Environmental Services - Water Quality
Onsite Wastewater Scan Data Entry Form

WAKE COUNTY DEPARTMENT OF ENVIRONMENTAL SERVICES WELL AND SEWAGE SITE LOCATION PERMIT
NO PERMIT(S) FOR CONSTRUCTION, LOCATION OR RELOCATION ACTIVITY SHALL BE ISSUED
UNTIL AN AUTHORIZATION FOR WASTEWATER SYSTEM CONSTRUCTION HAS BEEN ISSUED
PERMIT VOID IF NOT IN COMPLIANCE WITH ZONING REGULATIONS AND/ OR IF SITE IS ALTERED OR INTENDED USE CHANGED

IMPROVEMENT PERMIT

PRELIMINARY PLOT PLAN FOR:
DAVID-CARROLL HOMES

As Built

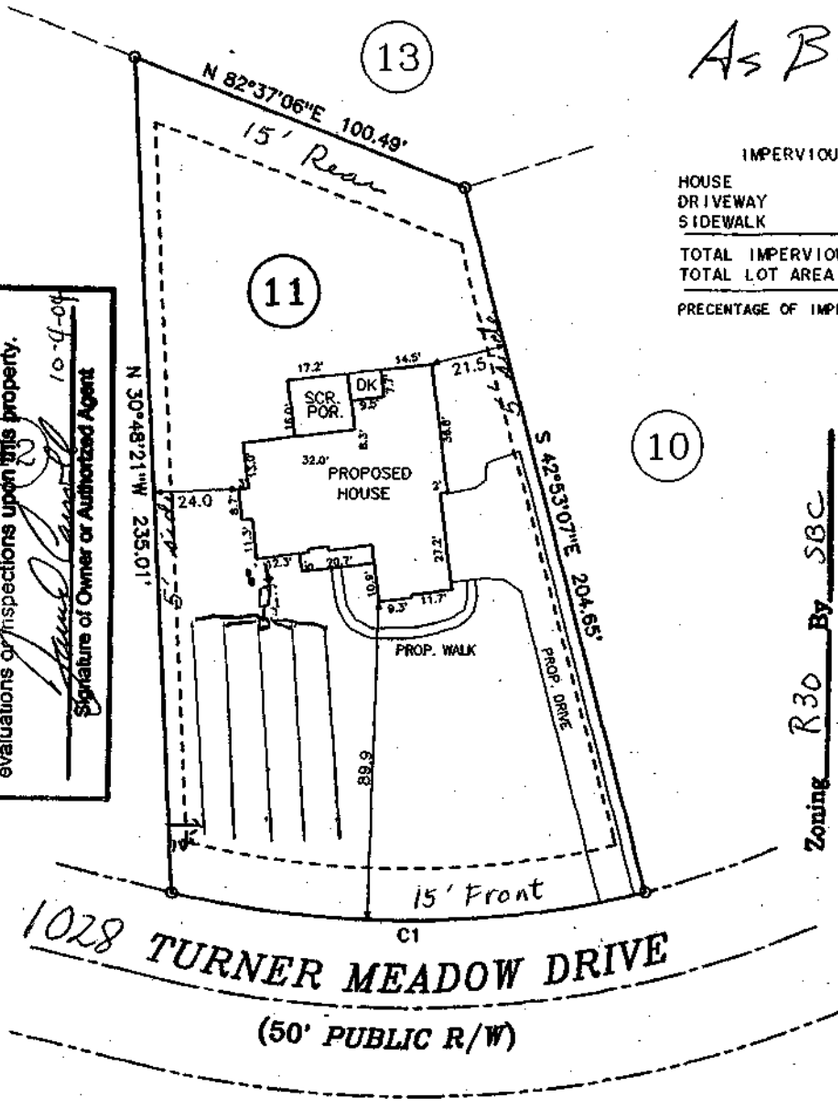
REVISED
Attn: Kathryn Hobby (E.S.)

PRELIMINARY PLOT PLAN FOR:
DAVID CARROLL HOMES

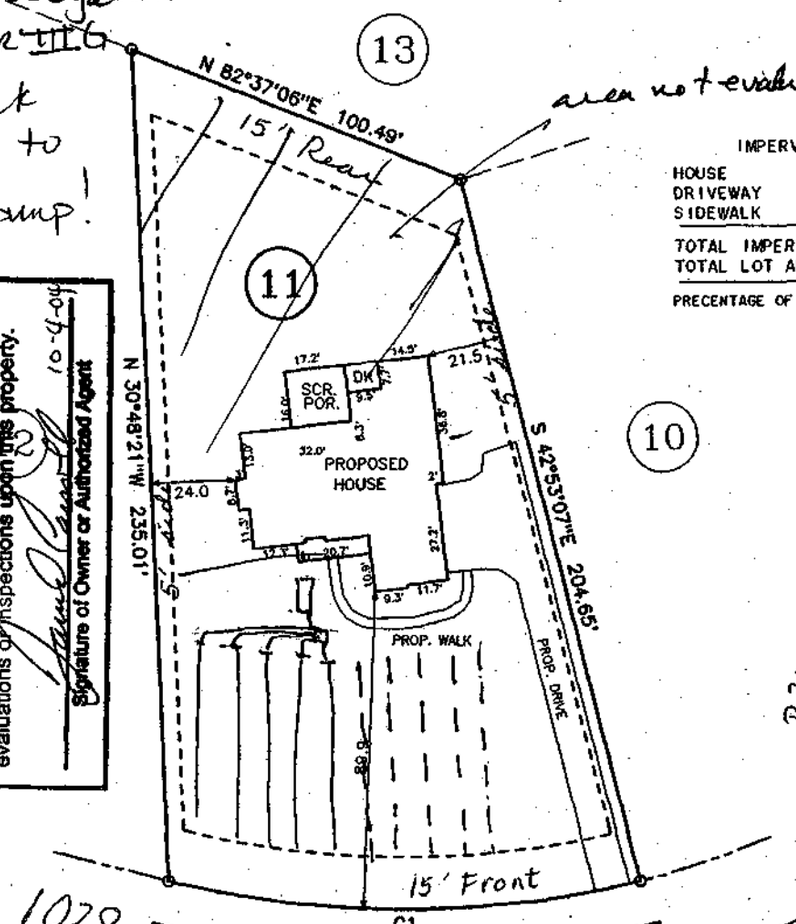
5x60'x3' @ 24" max depth
Innovative drainlines
use 1000gallon ST
Repair 111.6

Set tank high to avoid pump!
